Officers Report

Planning Application No: 147813 (WL/2024/00100)

PROPOSAL: Planning application to erect 4no. dwellings with detached garages, with new access and associated works.

LOCATION: Land at 31 Tillbridge Road Sturton by Stow Lincoln LN1 2BP

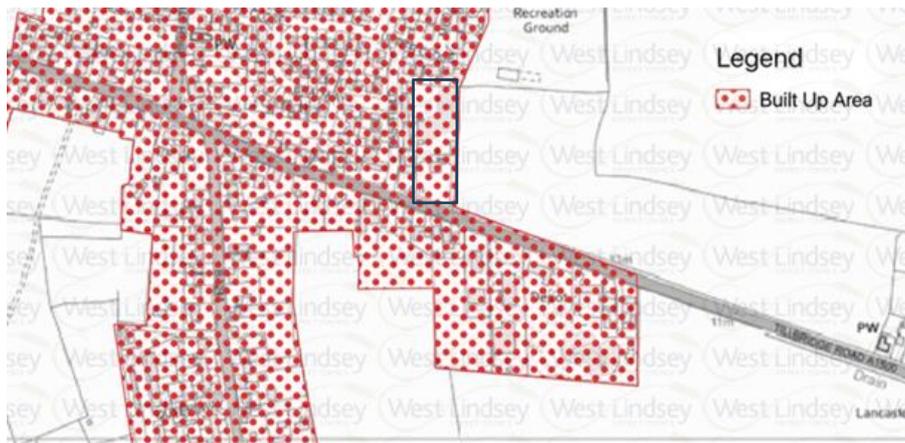
Below is a screenshot from Policy Map 2.1 of the NP showing the southern area of the Sturton by Stow Built Up Area. The black rectangle roughly indicates the site that is the subject of this application. The proposed site is considered to sit within the existing built up area of the village and would 'fill a gap' within this built up area.

In regards to criteria f) of the Policy 2 of the NP, the NP does not provide a definition of back-land development however it can reasonably be assumed that back-land development is development that sits behind an established building line of existing housing or other development, on land that is often used as garden land. The proposed development would be in the large rear garden area of 31 Tillbridge Road however there is not an established building line given dwellings forming Eastfield and Upper Close adjoin the site to the west and north. Notwithstanding this, it is not considered that the amenities of the nearby properties would be unacceptably harmed by the proposed development. The proposal is therefore considered to accord with Policy 2 of the NP.
